Project Erebus: Supplementary Environmental Information Addendum Report

1.1 Request for Further Information

- 1.1.1.1 This report has been produced in response to Natural Resources Wales (NRW) Marine Licensing's request, email dated 29 June 2022, for further information under the Marine Works (Environmental Impact Assessment) Regulations 2007 (as amended) for Marine Licence application ORML2170 Project Erebus. The Project is a demonstration scale Floating Offshore Wind (FLOW) development in the Celtic Sea region, proposed by the developer, Blue Gem Wind (BGW), a joint venture between Simply Blue Energy (SBE) and TotalEnergies.

Figure 2-22: Predicted patterns of long term sediment transport pathways in nearshore areas and detail around Turbot Bank.

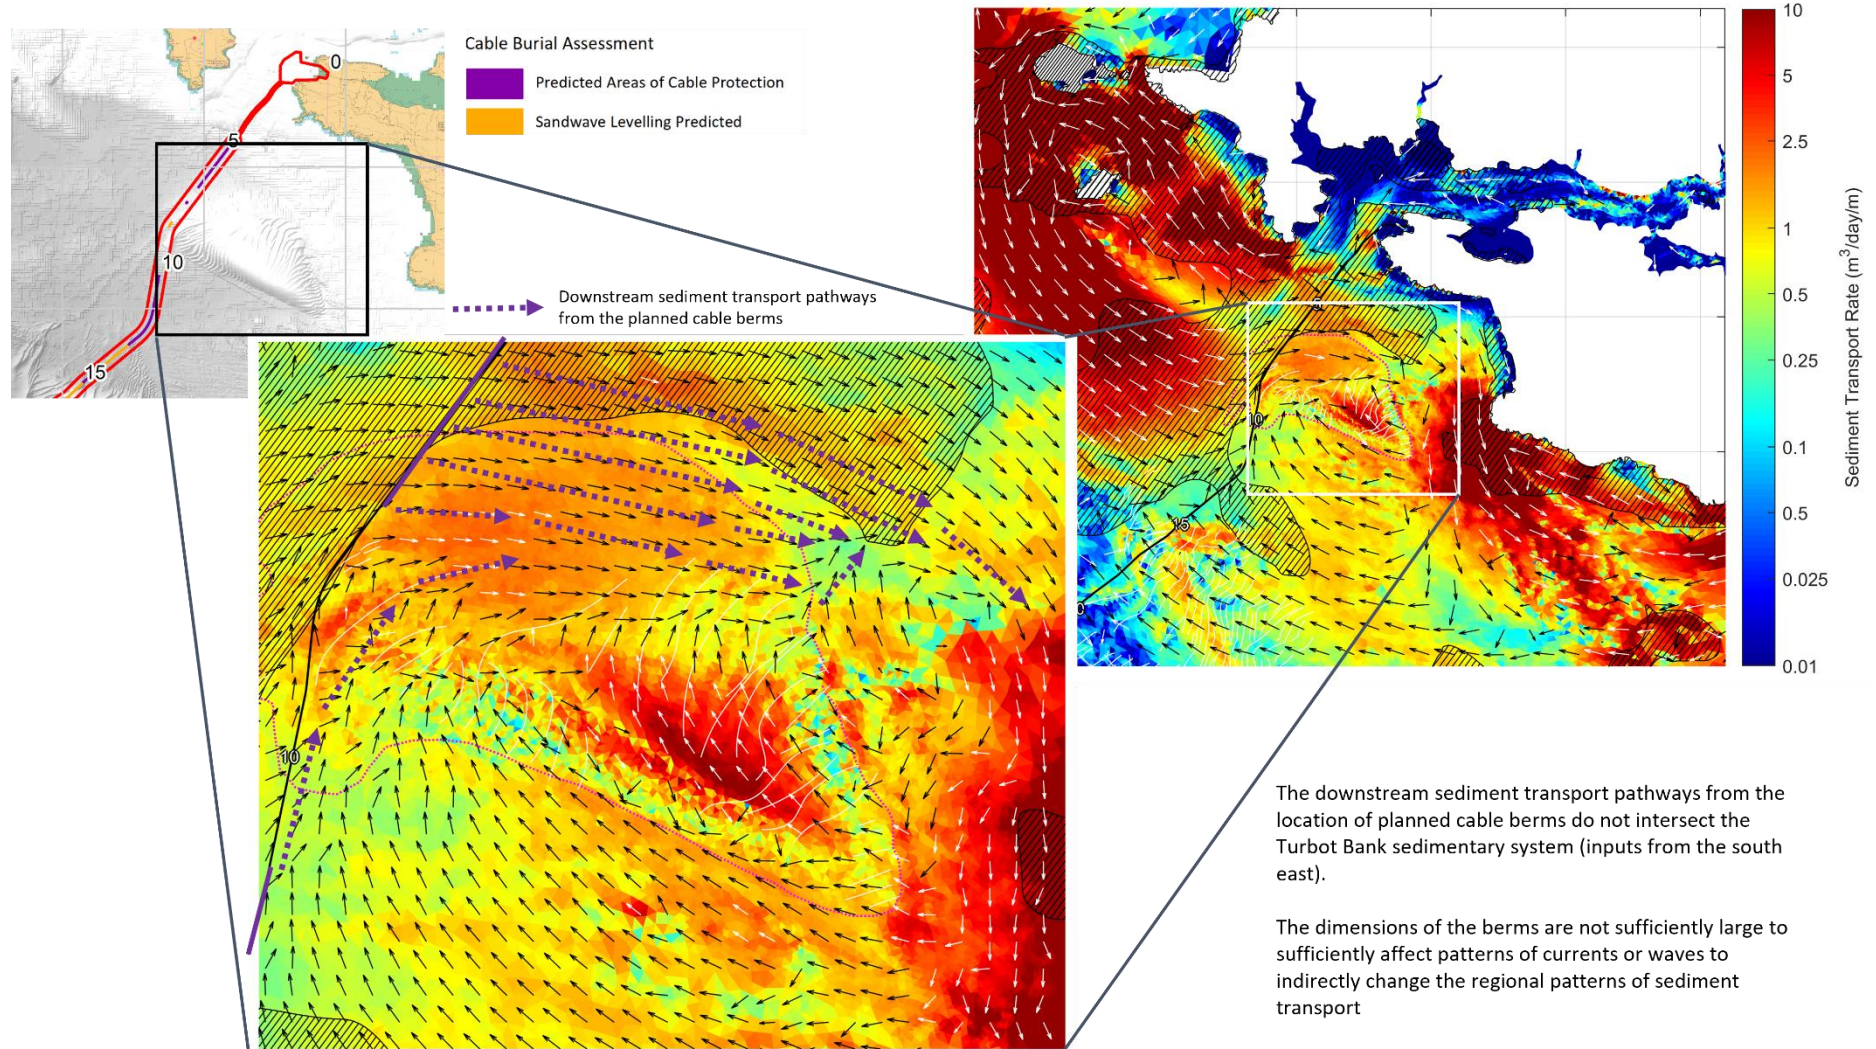
ES Vol. 1 Ch.6 Table 6.18 and ES Vol. 2 Figure 6.1 identifies that Annex 1 sand bank occurs in the SAC within and around the ECC at Turbot Bank (KP6.5 to 10.5) and within and around the ECC at KP 14.7 – KP17.7 outside the SAC... The sand bank at KP14.7 – KP 17.7 is potentially an Annex 1 habitat outside the SAC... We agree that in isolation, the small section of cable protection between KP7.1 and 7.3 (200m) will unlikely cause any changes to waves, tides and sediment transport and accordingly, no morphological change to the Turbot Bank is expected to occur with the cable protection in place (ES Vol. 1 Ch. 6 section 6.6.3.18). However, no consideration has been given to the impact that the two longer sections of cable protection detailed in ES Vol. 2 Figure 6.16 north and south of the Turbot Bank, and the cable protection proposed north and south of the sand bank system located at KP14.7 to KP 17.7, will have on the clockwise bedload sediment transport pathways and whether they could potentially impact on the morphological form and function of the Annex 1 sand bank systems over the operational phase of the Project. Until these assessments are carried out, we cannot agree that the cable protection will not cause a significant environmental impact to morphological form and function of the Annex 1 Sand Bank feature of the Pembrokeshire Marine SAC and the Annex 1 sand bank outside the SAC.

- 2.6.2.1 The assessment in the Project ES utilises modelled patterns of sediment transport, which describe a spatially complex pattern near and around Turbot Bank. The conclusions of the assessment are based partially on the lack of direct linkage (in terms of sediment transport pathways) between Turbot Bank and areas of seabed where external cable protection rock berms might be present. This point is illustrated in a more direct manner in Figure 2-22.

- 2.6.2.6 We have reviewed the basis and conclusions of the original assessment, accounting for the comments regarding uncertainty above. It is our expert opinion that the existing assessment and findings are sufficient to describe the potential level of impact and therefore properly informs the EIA and HRA. We trust it is understood, and agreed, that no fundamentally new evidence or assessment can be offered at this time. However, as set out within the Project ES and the Outline Environmental Monitoring Plan (OEMP), (prepared post ES submission and included as part of this submission of supplementary information), the Applicant (BGW) is committed to undertaking pre- and post-installation bathymetric surveys of the ECC, with a particular focus on areas of specific interest. Such areas include the section of the ECC that passes close to Turbot Bank, therefore, future monitoring of this area will provide further data to inform this issue and validate the predictions of this assessment.

Figure 2-23: Bedform migration rates within the array and export cable corridor

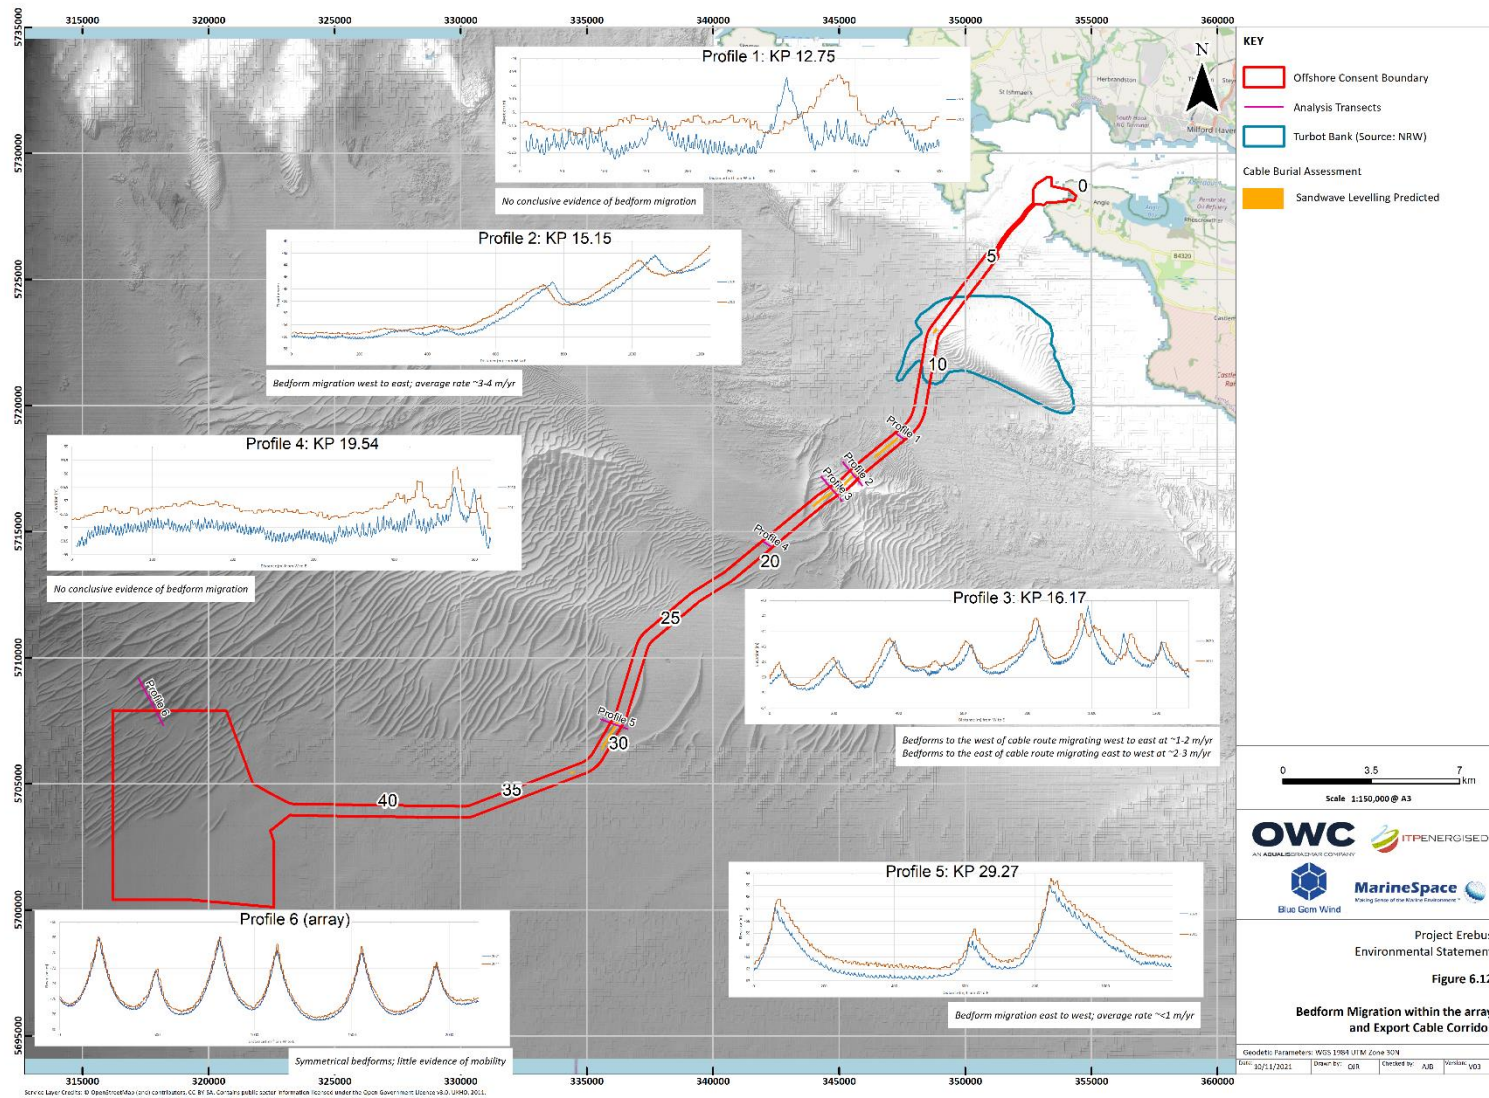
ES Vol. 1 Ch. 6 Table 6.19 and Vol. 2 Figure 6.12 shows the locations along the ECC where sand wave levelling is proposed. Particular attention has focussed on areas KP 8.0-8.5, 12.5-13, 13.5-14, 15-15.5 and 15.5 – 16.5 which is within the SAC sites. The magnitude of impact to the seabed resulting from sand wave levelling has been considered to be low. ES Vol. 1 Ch. 6 Section 6.6.2.34. The magnitude of impact has been assessed based on an assumption that the seabed will recover in response to short term seabed mobility driven by the short-term peak flood and ebb currents (note that the resultant maps of the instantaneous potential sediment transport rates were not presented (ES Vol. 1 Ch. 6 section 6.5.12.2)). Sand wave migration will also be influenced by waves, particularly in shallower locations. Given the uncertainties in the assessment of impact caused by sand wave levelling and the insufficient bathymetric data coverage, the rate of sand wave recoverability has not been adequately assessed and as a result we have low confidence with the magnitude of impact being assessed as low. ES Vol. 1 Ch. 6 Table 6.6 defines Low Magnitude as “Noticeable, temporary change (for part of the Project duration), or barely discernible change for any length of time, restricted to the near-field and immediately adjacent far-field areas, to key characteristics or features of the particular environmental aspect’s character or distinctiveness”. It is based on a semantic scale and not on time scales. Potentially, sand waves could take many years to recover or potentially never recover. We advise that a precautionary approach is taken in this case and that the magnitude of impact to be assessed as medium until further evidence has been presented which can quantify the recoverability of the sand wave features to be considered as low magnitude.

- 2.7.2.1 Where available (Figure 2-23), repeat historical bathymetric data sets of sufficient quality, have been used in the Project ES to estimate the migration rate of larger bedforms such as sandwaves. The quantity (coverage and number of surveys) and the quality (spatial resolution) of the repeat surveys was variable in the offshore array area and along the ECC, but was generally sufficient to make a reliable measurement in most key locations. The relative rates of migration (including areas of stationary bedforms) are consistent with the maps of net sediment transport magnitude created for the Study Area (e.g. Figure 2-22), which validates this source of evidence, in order to infer general sediment mobility magnitude, and the likelihood of bedform migration in other locations.

- 2.7.2.4 With respect, for the following reasons, no change has been made to the assessed magnitude of impact (Low) or the conclusion of impact significance (minor adverse) for this assessment.

Figure 3-1: Annex I sandbank extent overlaid with the Project baseline surveys of the ECC

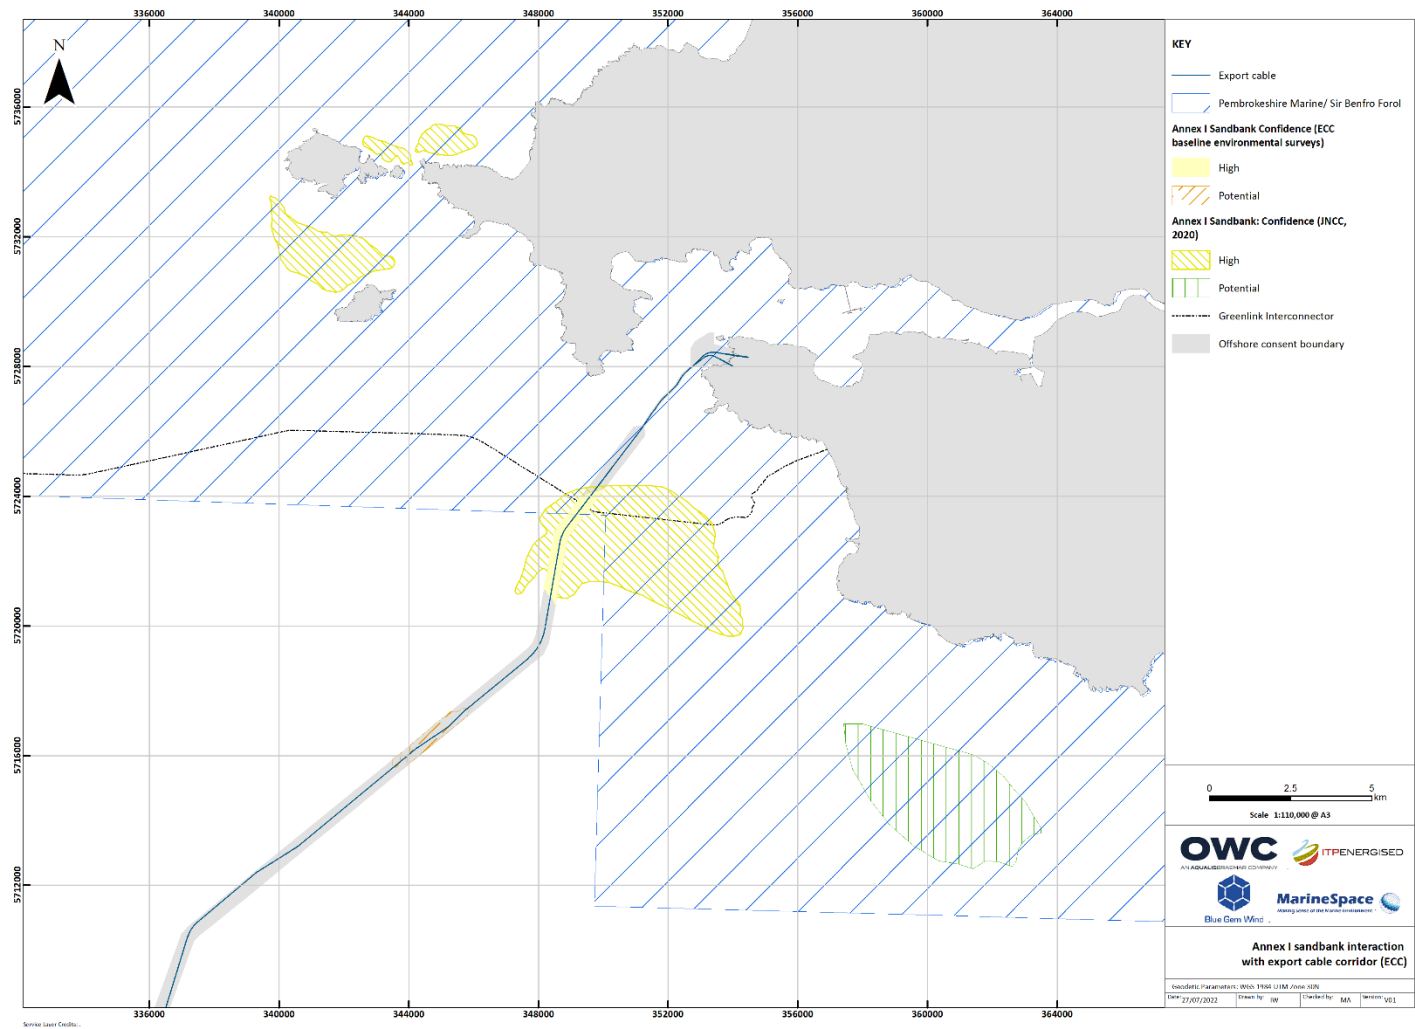
- 3.8.1.1 This section describes the sandbank feature that had been identified via EIA characterisation surveys outside of the boundary of the Pembrokeshire Marine SAC, intersecting the ECC at ~KP15-KP18. This feature had been assigned a 'Potential' confidence score as an Annex I sandbank. Following consultation, a re-assessment of this feature has been undertaken, to provide further clarification and confirm if it is deemed to represent a 'Potential' Annex I sandbank.

3.8.5.2 Figure 3-1 below shows that the latest JNCC data do not predict any 'Potential' sandbanks near to, or overlapping the 'Potential' feature, that had been identified through the baseline surveys.

Figure 7-1: Historical incident analysis (extended to 1992-2021) (top= Array Area plus 10km, bottom=Cable Corridor plus 10km).

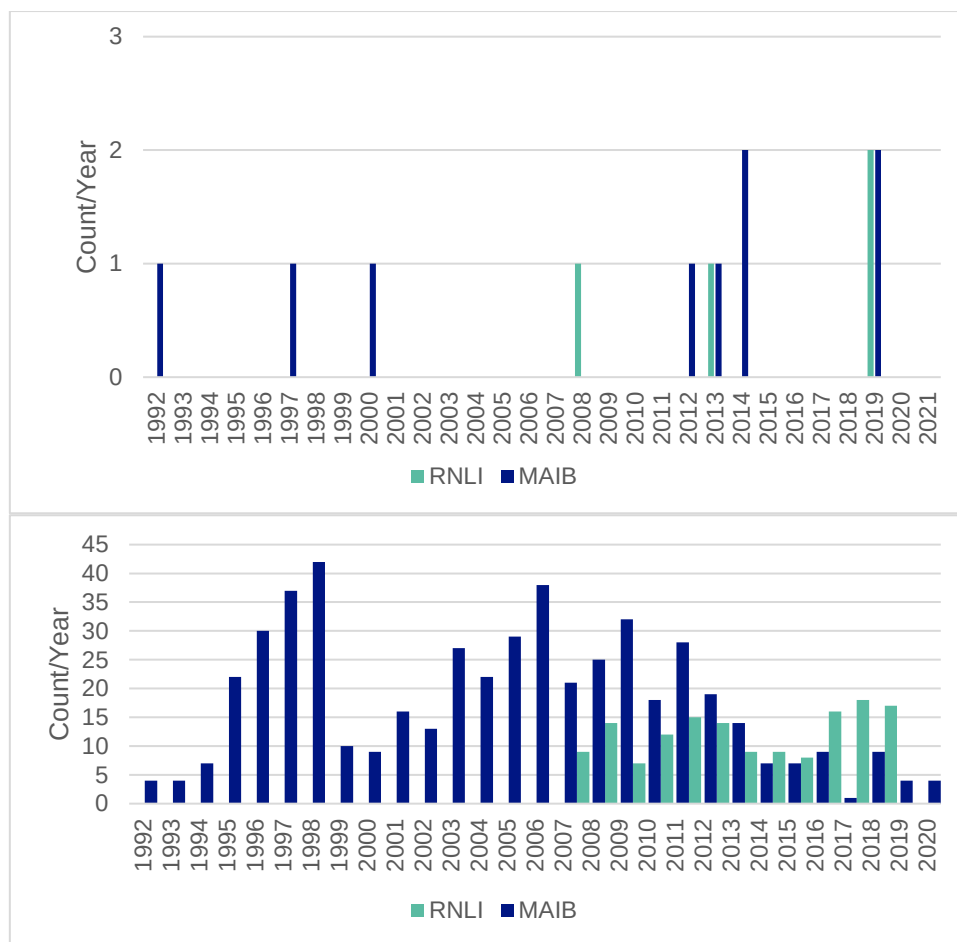
- 7.2.1.2 The Applicant notes the CoS comments regarding a longer term dataset (which has subsequently been received from the MAIB), an updated analysis of which is provided below, and in Figure 7-1 to Figure 7-3. These do not show a substantial difference in accident frequency near to the array area, with three additional incidents accounted for by mechanical failures aboard fishing vessels. Near to cable landfall, the number of MAIB reported accidents has declined since 2010. We believe that the results of this supplementary analysis do not substantially change the conclusions of the NRA and therefore the statement on navigation safety of the Project.
